Expert Witness Report in
Rebuttal to Idaho Water
Engineering Report on
Application for Transfer
No. 85639

IMH Boise Cimmaron, LLC

Project: 10346993

Canyon County, Idaho
January 5, 2024

Figure 1. Groundwater Level Data and Trends

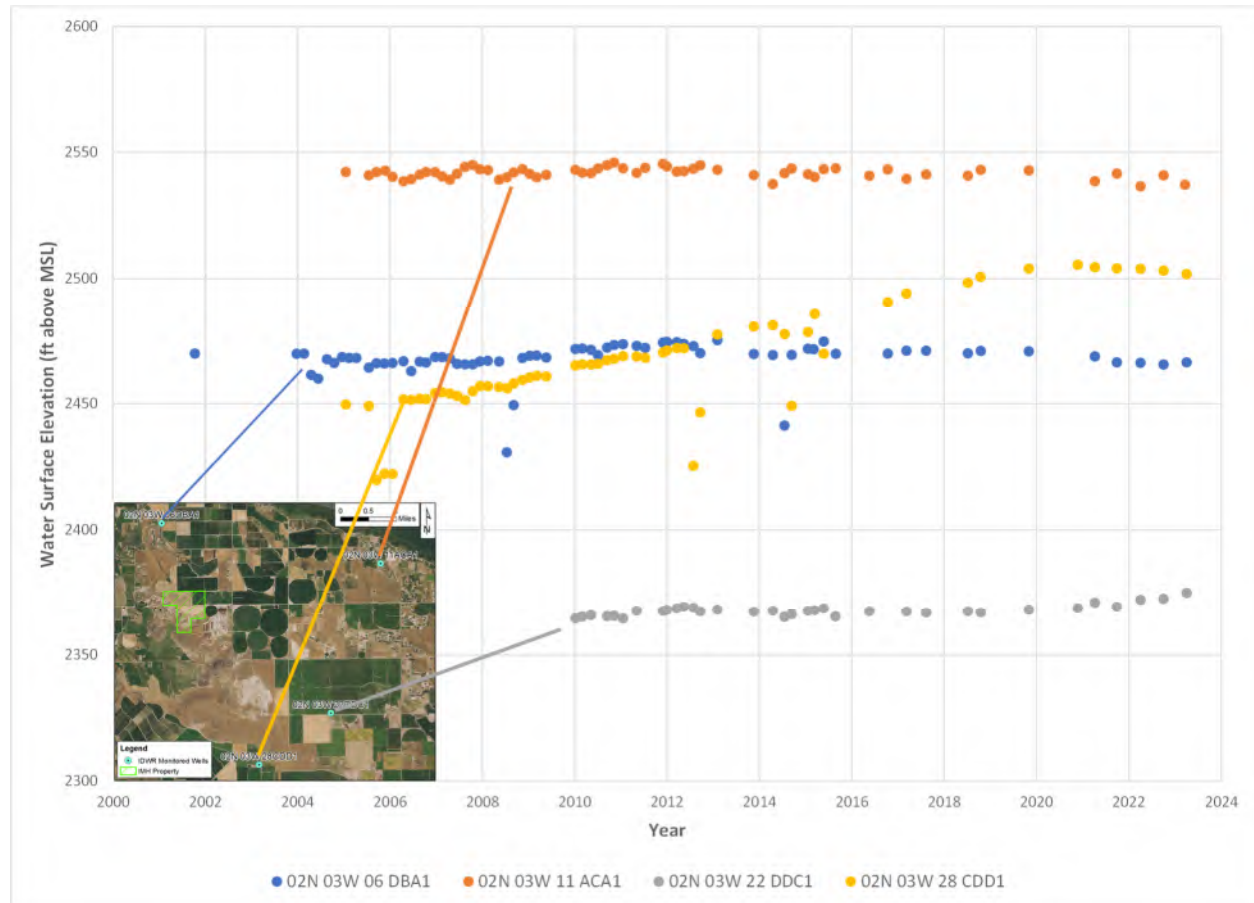
IWE claimed "Unfortunately, there are no IDWR program wells in the vicinity of Breanna (sic) and IMH that are being monitored for ground water levels in the **deeper Idaho Group aquifers**." (emphasis added). HDR identified four Idaho Department of Water Resources (IDWR) program monitoring wells in the vicinity of the Application and Beranna Dairy, two of which appear to be completed in the deeper Idaho Group (HDR, 2023).

Figure 3 in HDR's *Expert Witness Report in Support of Application for Transfer No. 85639* plotted groundwater levels from the four identified IDWR Groundwater Data Portal wells near the IMH property. After further review, HDR identified that a portion of data from well 02N 03W 28 CDD1 was omitted. Figure 1 below provides the full record of all four wells with water levels presented as water surface elevations above sea level.

The two wells located southeast of IMH and Beranna Dairy, 02N 03W 28 CDD1 and 02N 03W 22 DDC1, appear to be completed in the deeper Idaho Group and both exhibit long-term stable or increasing water levels.
